**ABBOTT
ADD**

TECHNICAL SERVICE BULLETIN

SUBJECT:
Extended Waste Option

PRODUCT:
AxSYM® (83)

Figure 1

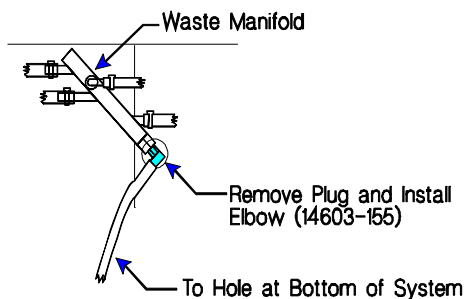
9. Remove the rear center access panel.
10. Using paper towels or other material, cover the cables below the manifold.
11. At the Waste Manifold, locate and remove the plug on the right side of the manifold. (Refer to Figure 1)

S/N \geq 1000 Apply Teflon® tape and install the Elbow Fitting (14603-155) into the opening and direct the output down.

GOOD Tubing Routing
Figure 2

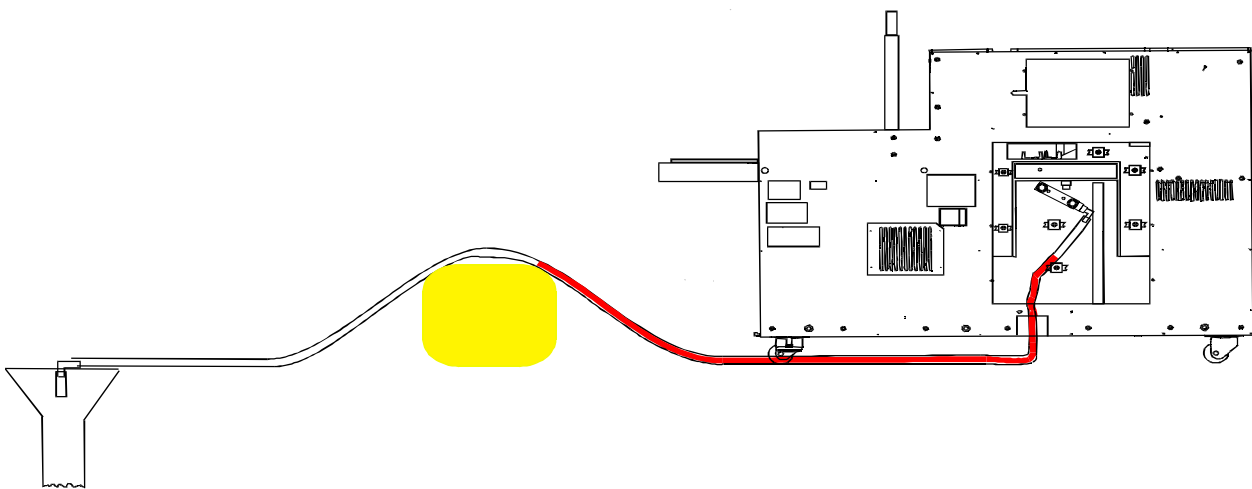
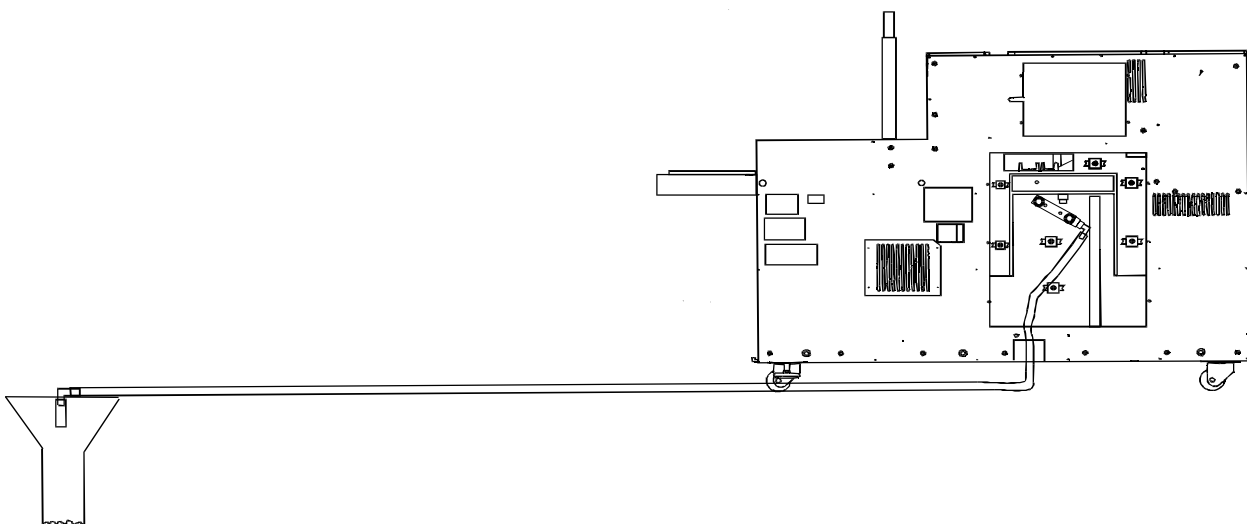
NOTE: As the tubing is routed to the floor drain, it must not be allowed to rise more than 7.5 cm (3") off the floor.

Figure 1

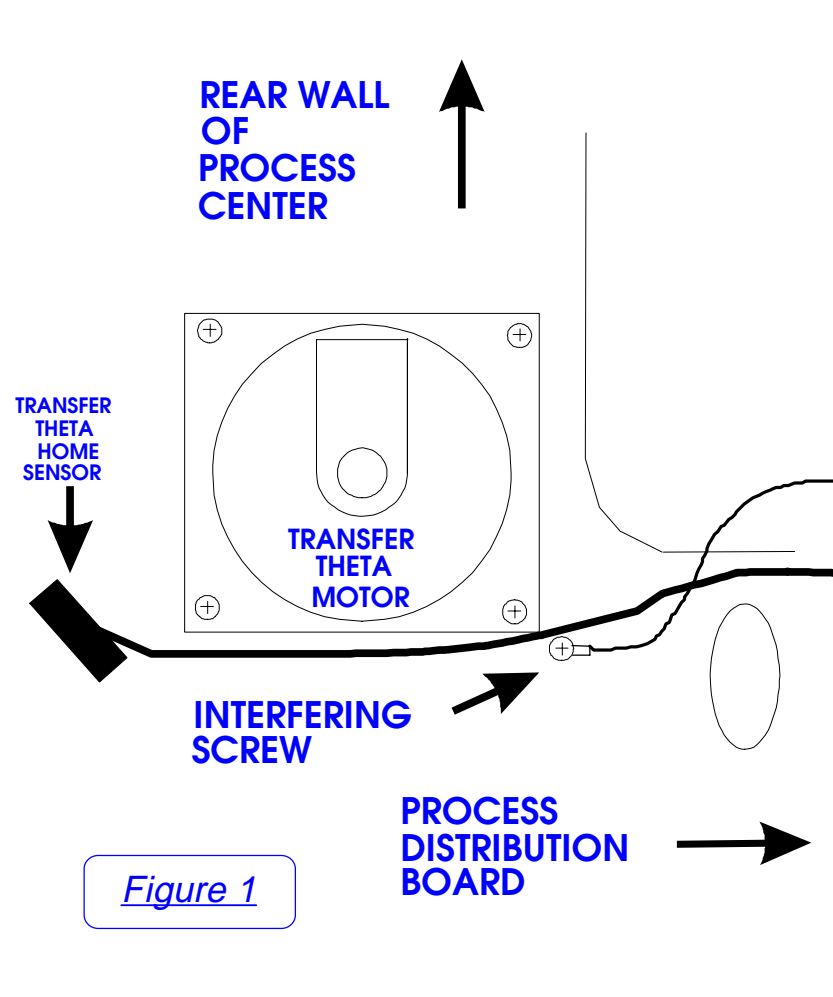
Some instruments have a screw holding the ground wire for the Transfer Theta Motor that is too long. This mechanical interference can lead to errors when loading and unloading RVs. See Figure 1 on page 3 for the location of this screw. Note that Process Distribution Board Shroud

is removed in this illustration to clearly show the location of the screw. The resolution is to remove this screw and replace it with a shorter one. The screws that were initially installed are 10-32 Sems screws, 5/8" long (P/N 14494-310). The screw that replaces the old one is a 10-32 Sems screw,1/2" long (P/N 14494-308).

6. Remove the old screw (interfering screw as shown in Figure 1).
7. Install the new screw.
8. Remove the Processing Carousel Cover.
9. Remove the Processing Carousel.
10. Rotate the Transfer Mechanism slowly by hand in the counter-clockwise direction until it is aligned with the RV Carousel transfer station to verify there is no mechanical interference.
11. Re-install the Processing Carousel.
12. Re-install the Processing Carousel Cover.
13. Re-install the Process Distribution Board Shroud.
14. Power up the AxSYM™ Analyzer.
15. Load and retrieve an RV using Diagnostic Controls to verify proper operation.
16. Close the Processing Center Center Cover.
17. Install the Matrix Cell Hopper.
18. Perform an instrument start-up
19. Discard the old screw.
20. Mark off box 9 on the Modification Control Sticker.

FIGURE 1

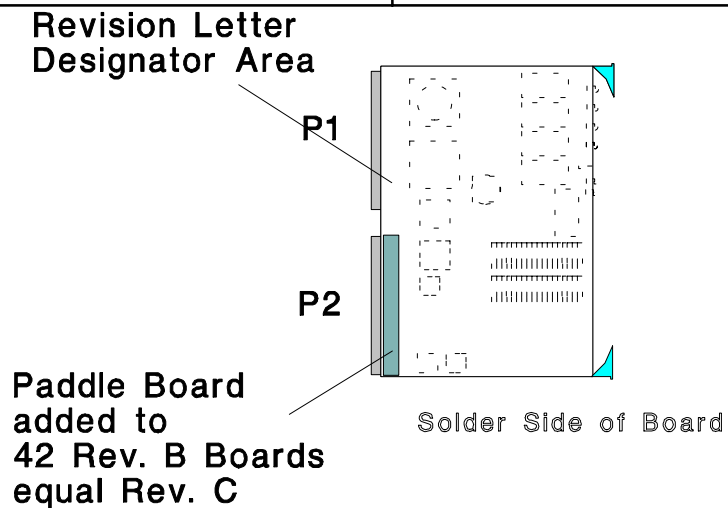
1. Power down the AxSYM system in accordance to the shutdown procedure.
2. Remove board 1 from the VME card cage.
3. Examine the solder side of the board and look at the REV. level on the board (It should have 42B or 42A located next to P1 - Refer to Figure 1).
4. If this is a Rev. 42B board without the attached 47pf board it must be replaced with a 4-37333-02 (Rev. 42B or 42C) board with an attached 47pf board. Rev. 42A boards are not affected.

OK	BAD
16 Meg CPU Boards with any of the below Revisions	All 8 Meg Boards
Rev 42A	16 Meg CPU Boards Rev 42B
Rev 42B with P2 Paddle Board	without P2 Paddle Board
Rev 42C

Figure 1

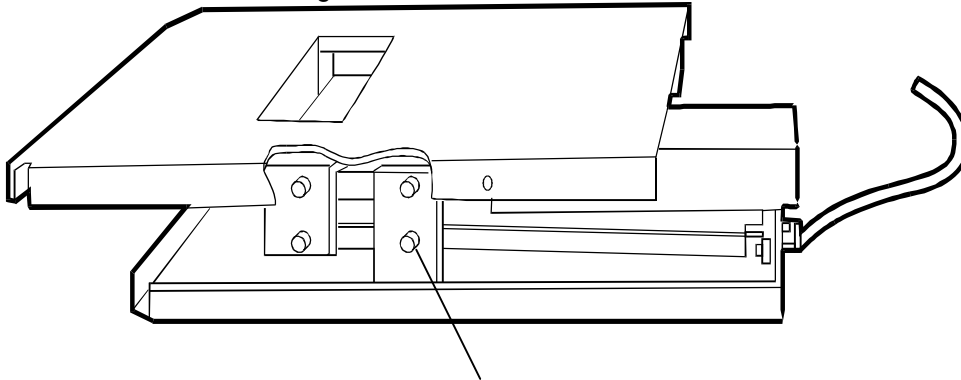
3. Remove the screws that hold the black plastic stops in place and discard both.
4. Remove the two shoulder screws, one on each side, that hold the platform to the pivot point of the assembly (Refer to Figure 1).

5. Install the new bellville washers (P/N 14533-002) under the head of the existing shoulder screws, then replace the screws into that pivot point (Refer to Figure 1). This will remove any side to side movement of the platform.

Figure 2

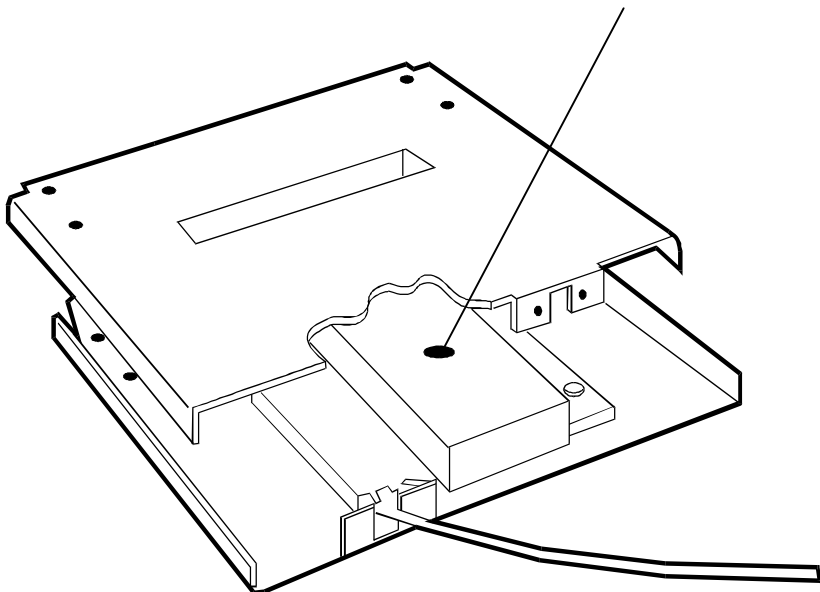
6. Remove the screw and washer that hold the old counterweight in place. Save this screw and washer. Discard the old counterweight.
7. Install the new counterweight (P/N 38226-102) using the screw and washer from the old weight (Refer to Figure 2).

Fig. 1

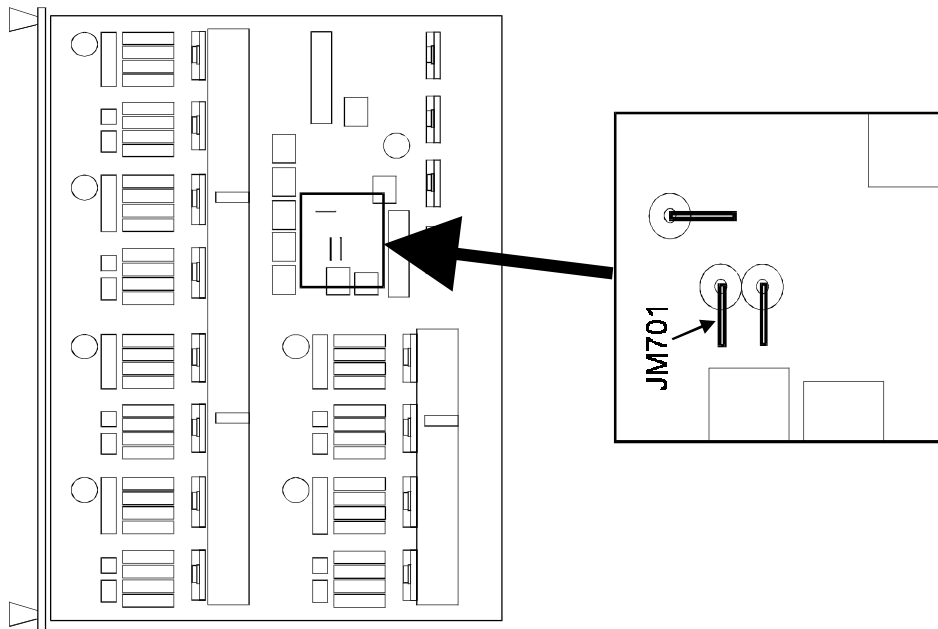
1. Perform the instrument shutdown procedure and power off the system.
2. Access the Card Cage Assembly by removing the Card Cage Access Panel cover.
3. Remove the Power I/O PCB (37430) in slot #4 of the power card cage.
4. Locate jumper JM701 referenced in Figure #1.

Fig. 2

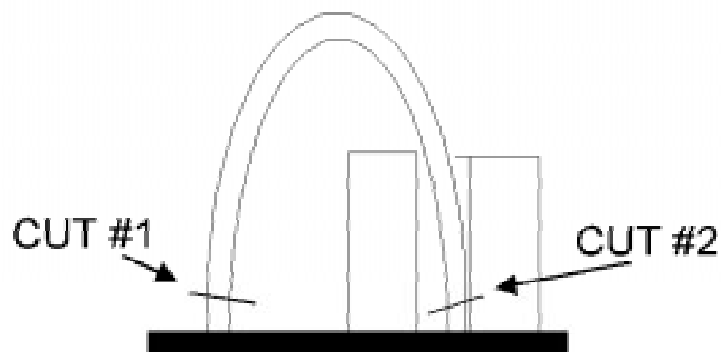
5. Using wire cutters, cut jumper JM701 as close as possible to the board for each leg. See Figure #2.
6. Verify that all pieces of the jumper are removed from the board to prevent possible shorting.
7. Re-install the modified Power I/O into the card cage.

Figure 1

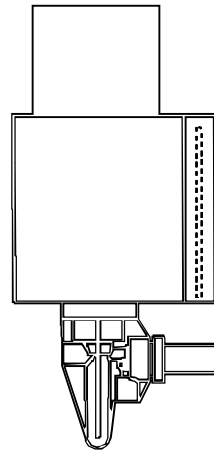
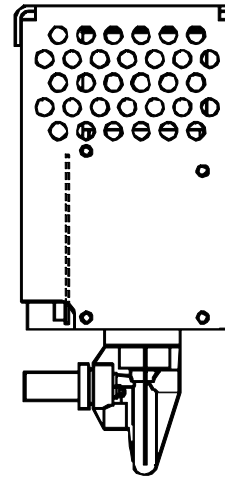
covers the motor and the PCB. (Refer to Figure 1.) The cause of the cracks is related to the plastic parts used to assemble these syringes. The plastic parts flex during a normal flush cycle. This flexing causes the syringe piston to hit the bottom of the syringe body which has the potential to result in cracks and leaks.

Figure 3 - Diluent Pump Inlet Tubing Routing

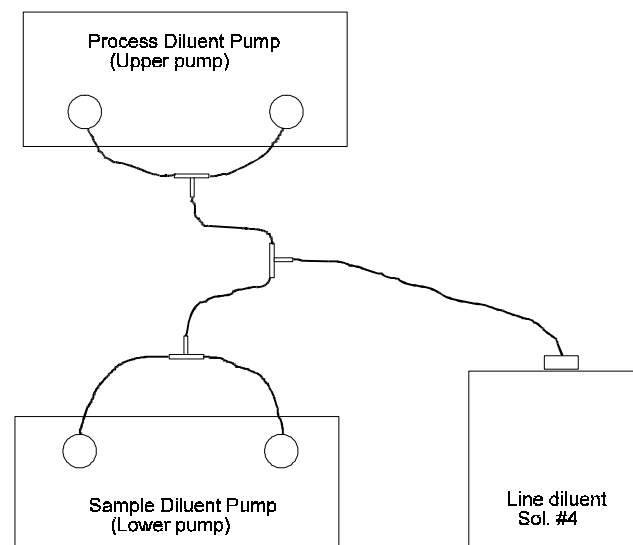
IMPORTANT: Review Figure 3 before attaching any tubing to the diluent pump (front) input side. Once any of the new tubing is installed it cannot be removed. It is a very tight fit. Cutting the tubing back off makes it too short! (It may be helpful to use Figure 3 and label the tubing "upper" and "lower" before continuing.)

10. Using Figure 3, install the correct ends of the Buffer Supply tubing set to the inlet ports on the sampling pump. Hold the back of the pump while installing the tubing. Push the polyurethane tubing completely onto the inlet ports. Wetting the tubing with DI water can be helpful in installing the tubing.
11. Install a tubing tie wrap (14276-108) over the tubing at the inlet ports as shown in Figure 2. Do not use cable tie wraps on tubing. Use only the tubing tie wraps provided in the TSB kit.
12. Carefully secure the sample diluent pump to the Supply Center back wall. Be sure not to crush any tubing!
13. Remove the upper (processing) diluent pump from the Supply Center wall.
14. Remove the two 6" pieces of tubing from the circle "T" fitting to the output (back) side of the sample diluent pump.

19. Using Figure 3, install the correct ends of the Buffer Supply tubing set to the inlet ports on the processing pump. Hold the back of the pump head while installing the tubing. Push the polyurethane tubing completely onto the inlet ports. Wetting the tubing with DI water can be helpful in installing the tubing.
